VOLLER RV STORAGE
EROSION CONTROL PLAN

SHEET 3 OF 7
JOB NO. 25251.00

VOLLMER RV STORAGE

POND DETAILS

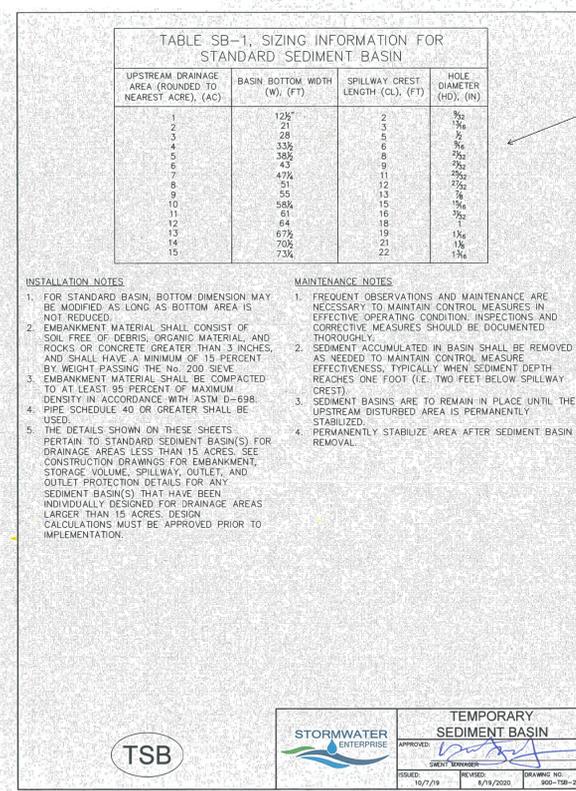
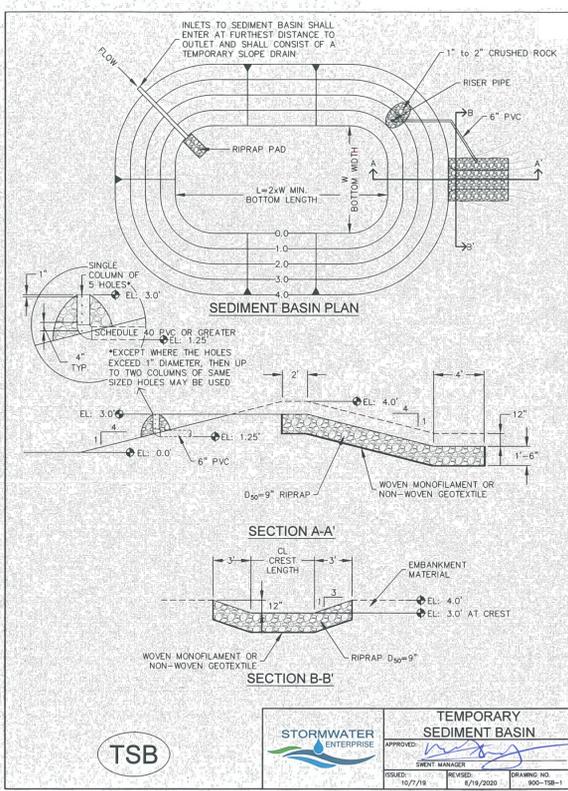
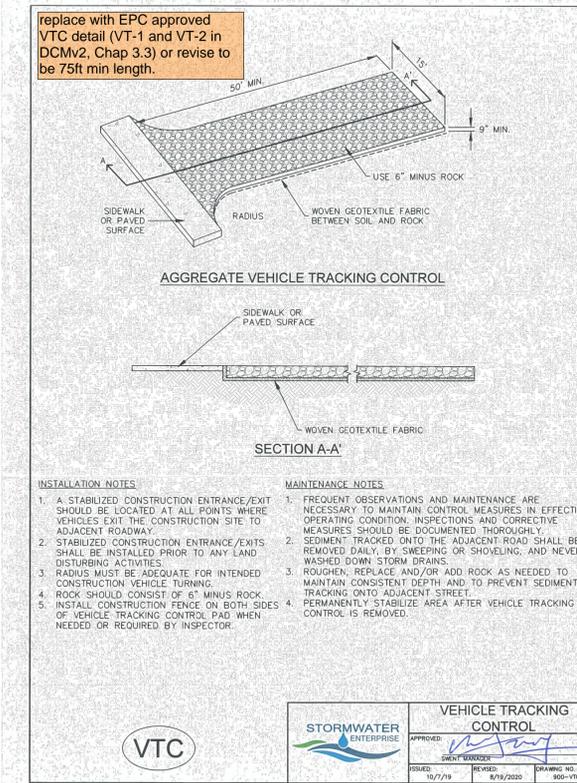
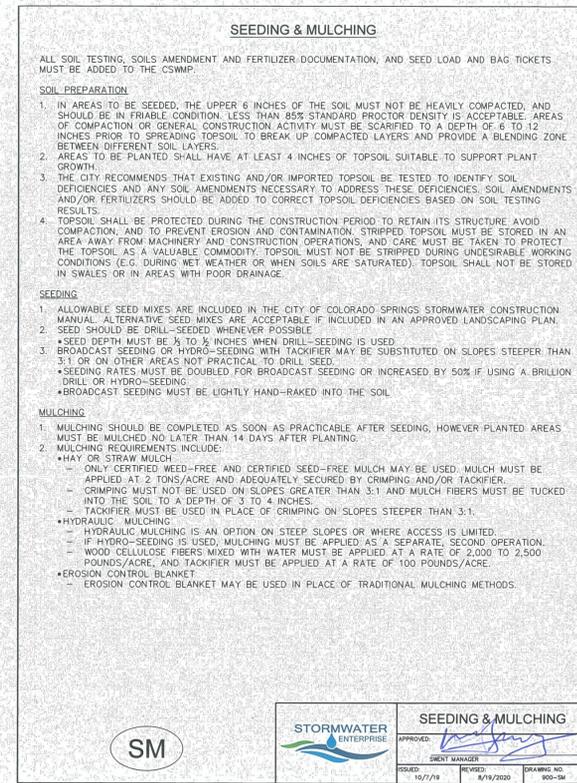
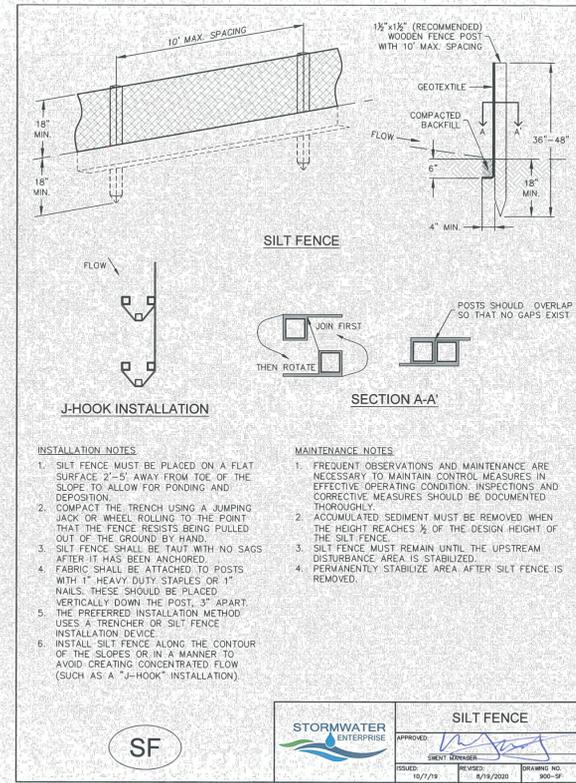
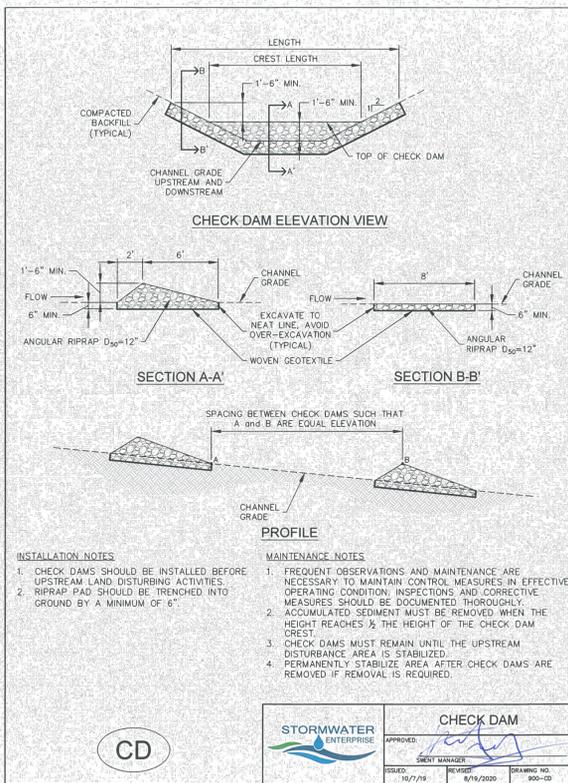
call out which sizing applies

GEC DETAILS

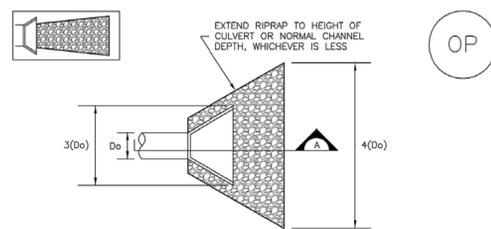
include concrete washout detail and inlet protection detail
